## ANN ARBOR HISTORIC DISTRICT COMMISSION

### Staff Report

**ADDRESS:** 514 N. Division Street, Application Number HDC16-176

**APPLICATION:** The applicant seeks HDC approval to install two basement egress windows and wells in place of existing basement windows.

**2062 MODEL WELLCRAFT  
WELL SYSTEM**

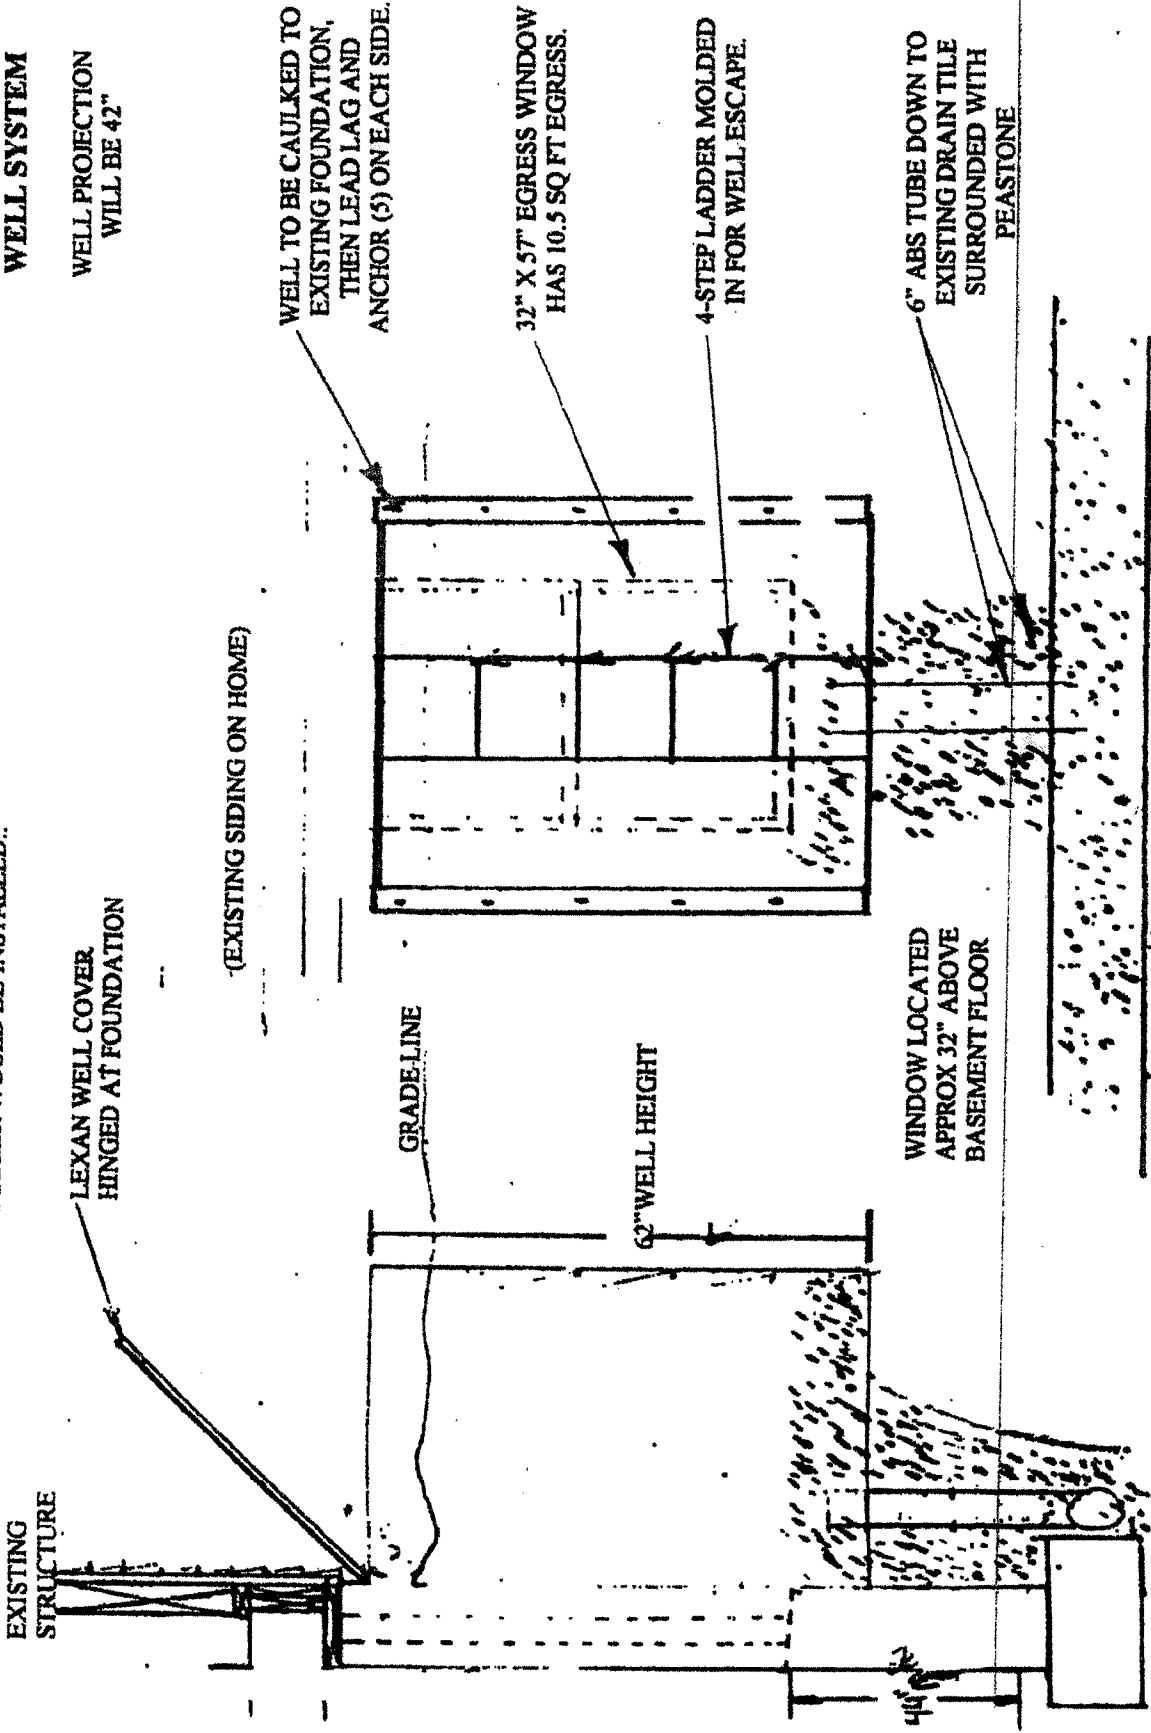
1. The basement egress windows would be on the south (side) elevation and replace existing basement windows. Each of the egress windows is 32" x 57", made of vinyl, and the wells are 18 gauge steel with a metal ladder and polycarbonate plastic cover. Each well projects out approximately 45" from the face of the window and is 62" deep.
2. The property owner desires to add two bedrooms and a bathroom to the basement of the house. The small size of the lot prevents any additions to the house. The proposed location will be visible from the public right of way, especially the one closer to the street. Other windows looking out of the basement are obstructed by mechanical equipment.
3. Because of the lot constraints staff believes the proposed egress windows are appropriate and that the application generally meets the Standards and Guidelines used

I move that the Commission issue a certificate of appropriateness for the application at 514 N. Division Street, a contributing property in the Old Fourth Ward Historic District, to replace two existing basement windows with egress windows and wells on the south elevation, as proposed. The work is compatible in exterior design, arrangement, texture, material and relationship to the rest of the building and the surrounding area and meets the *Ann Arbor Historic District Design Guidelines*, especially those for windows, and the *Secretary of the Interior's Standards for Rehabilitation and Guidelines for Rehabilitating Historic Buildings*, in particular standards 2, 9 and 10 and the guidelines for windows.
